STAFF RECOMMENDATION

S. Dettman
NCPC File No. 6985

FEDERAL RESERVE WILLIAM MCCHESENEY MARTIN, JR. BUILDING VISITOR SCREENING AND CONFERENCE CENTER ADDITIONS

February 25, 2010

Proposed site plan

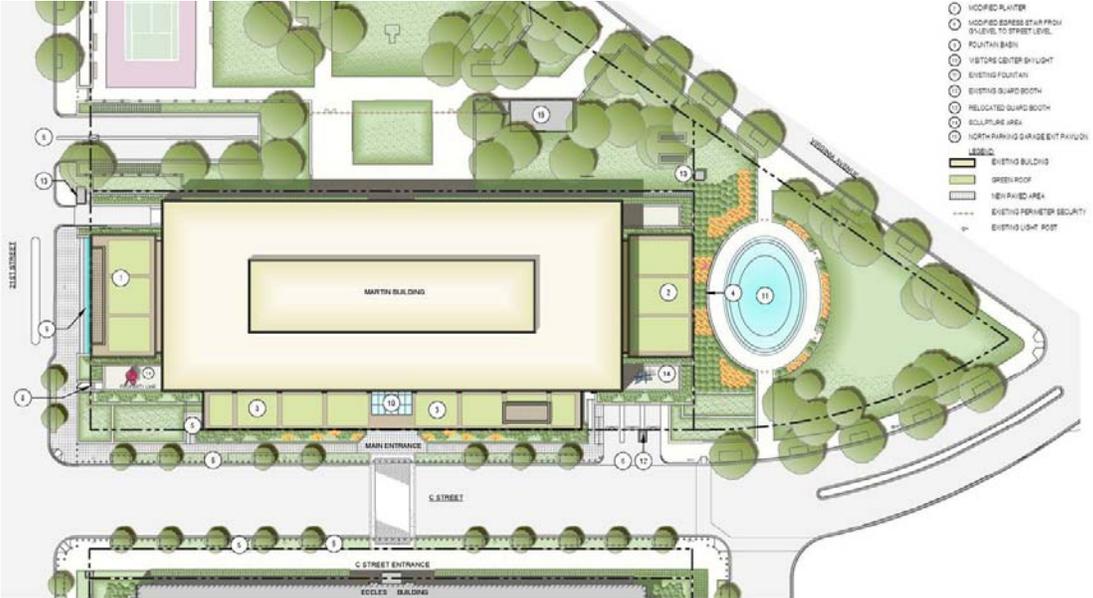
Included in the proposed concept is the relocation of a guard booth located in public space along 21st Street. Currently, the booth is located along the southern edge of a vehicular entryway that provides access to the Martin Building's loading dock. The proposal is to relocate the booth to the north side of the entryway while still placing it in public space. According to the Commission's policies, “vehicular controls at building entries, such as vehicle barriers and guard booths should be located so that pedestrian movement along sidewalks is not blocked.” While the booth's existing location likely pre-dates this policy, in order to improve the quality of the streetscape along 21st Street staff encourages the Federal Reserve to assess whether the booth could be relocated on site or eliminated entirely.

Requires the Federal Reserve to work with staff to determine whether the guard booth along 21st Street can be relocated inside the Martin Building property lines.

Proposed south elevation (C Street)

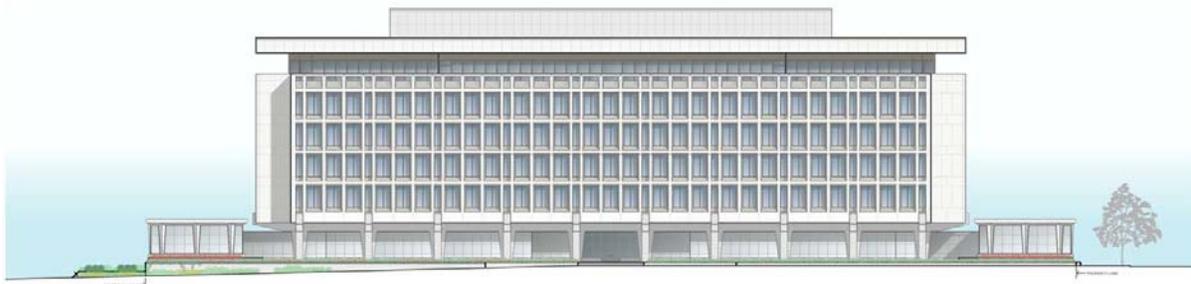
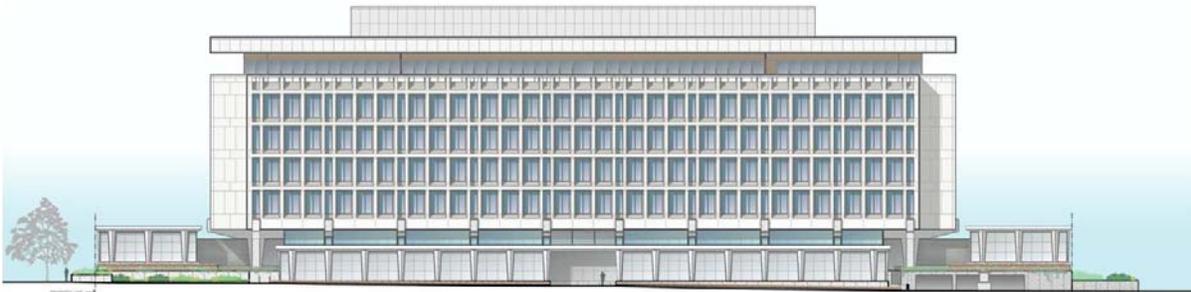
As mentioned above, the Martin Building was constructed in the mid-1970s in the Modernist architectural style. Elements such as the elevated podium, supporting pilotis, and surrounding landscaped open space are some of the building's most defining characteristics, and reinforce the Northwest Rectangle's overall sense of openness. While the entire proposed concept has the potential to intrude upon this sense of openness, the potential is most notable along C Street at the proposed visitor screening center. As mentioned above, the proposed one-story visitor screening center will extend almost the entire length of the C Street façade, and extend out to the property line. Currently, the distance between building face and the property line is approximately 20 feet, and approximately 30 feet between the building face and the inside edge of the sidewalk. The proposed visitor screening center will reduce these distances to zero and ten feet, respectively. While the reduction will not impede access to the public space, it does have the potential to detract from the quality of the space, and from the original design intent of the building.
